Appendix C – Evidence of Federal Land Manager Consultation and Nevada’s Responses to Formal Comments

Appendix C.1 - NDEP Responsiveness Summary

Responsiveness Summary to Federal Land Manager Comments as of July 21, 2022

Figure 1- Example (Bryce Canyon) WRAP TSS Product #5, Model Express Tools

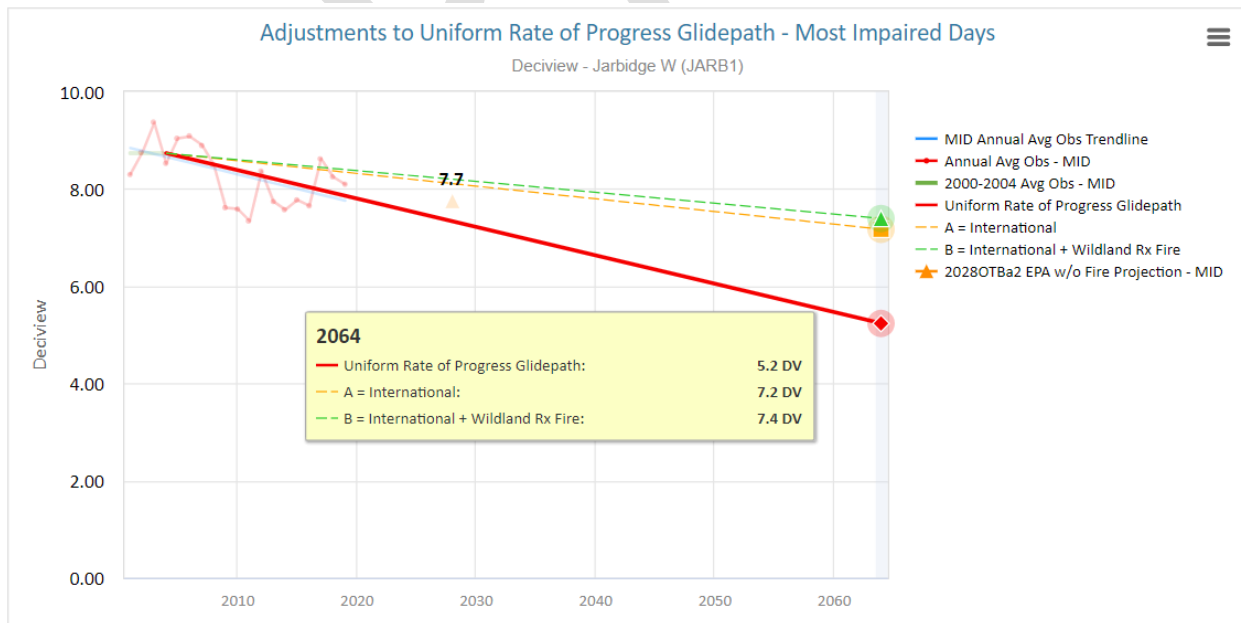
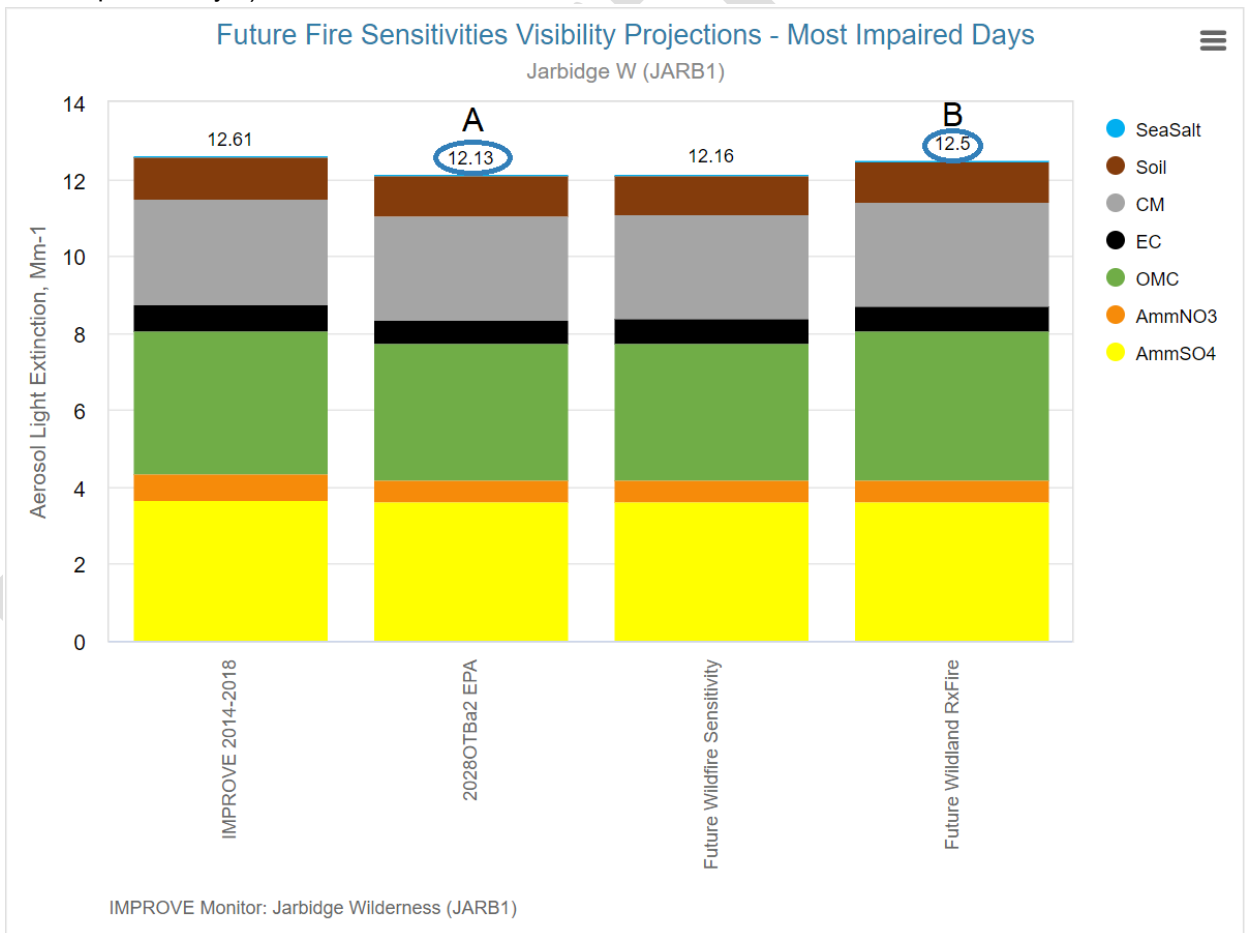
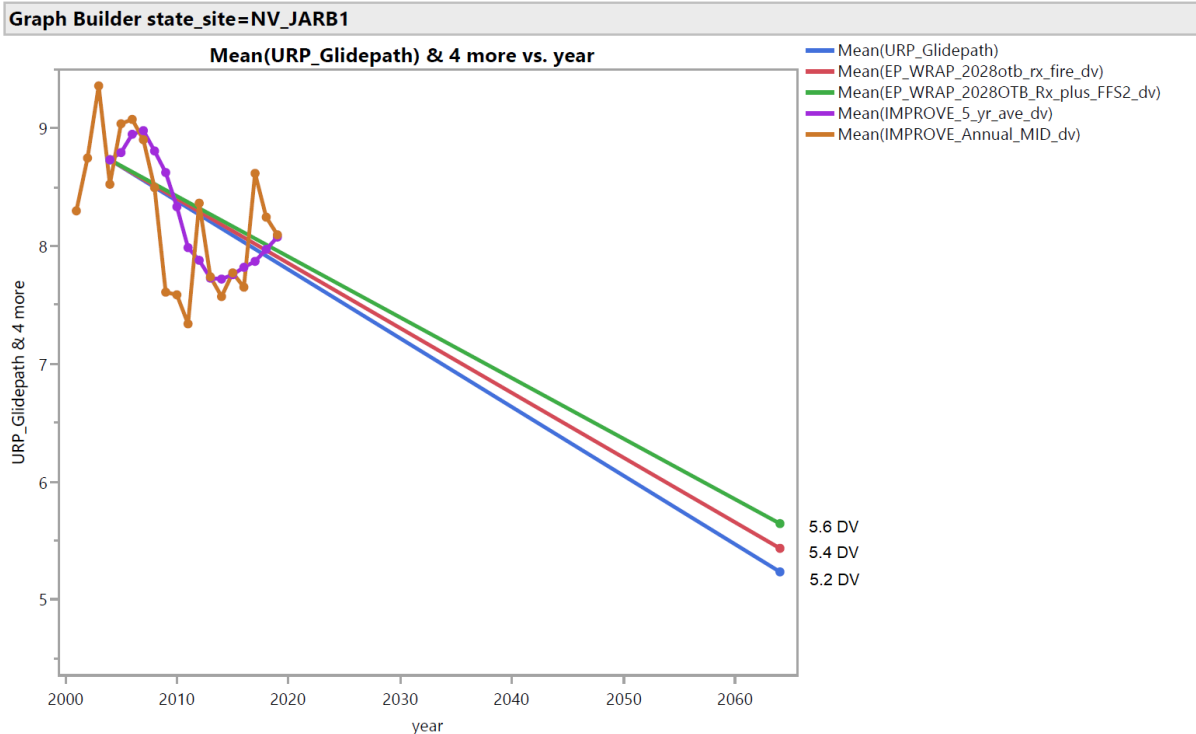
COMMENT 5 (FS): *The USFS encourages NDEP to use the adjustment of glidepaths for the increased prescribed fire projections reflected in the “Future Fire Scenario 2” available in Product 18 of Modeling Express Tools of the Western Regional Air Partnership (WRAP) Technical Support System (TSS).*

2. Subtract “End Point A – International” from “End Point B – International + Wildland Rx Fire”
3. Example- Jarbidge (JARB1): B = 7.4 DV, A = 7.2 DV. Rx fire component of adjustment = B – A or 7.4 – 7.2, which yields 0.2 DV difference or “default endpoint adjustment for Wildland Rx fire.”

- a.
 - i. 2028 OTBa2 results: stacked bar chart, column 2 = 12.1 Mm⁻¹ (Figure 2, “A”)
 - ii. 2028 FFS2 results: stacked bar chart, column 4 = 12.5 Mm⁻¹ (Figure 2, “B”)

6. Figure 3 shows the final results, with the green line including the 0.4 DV adjustment. Prescribed fire is expected to ramp up over the next decade. Without this adjustment to the 2064 endpoint deciview value, then impacts from increased prescribed fire activity may prevent states from remaining beneath the URP even if other haze-causing pollutants are reduced.

RESPONSE 5: After careful consideration, the NDEP has elected not to make the additional 0.2 dv USFS proposed adjustment to the glideslope for the second implementation period of Nevada’s Regional Haze SIP. Although an increase in prescribed fire burning is indicated in strategies and plans listed in Nevada’s Shared Stewardship agreement, NDEP has elected to rely on a more conservative Uniform Rate of Progress (URP) glidepath that doesn’t assume increases in prescribed fire into natural conditions at Jarbidge Wilderness Area (WA) to prevent excess “flattening” of the URP glidepath. Whether or not an additional 0.2 deciview increase is made to the natural conditions metric to account for increases in prescribed fire burning, the calculated Reasonable Progress Goal (RPG) during the most impaired days for Jarbidge WA in 2028 still remains below the URP point for 2028. NDEP recognizes the important role of prescribed fire emissions in Regional Haze and will reconsider quantifying the increased prescribed fire visibility impacts in future planning periods.
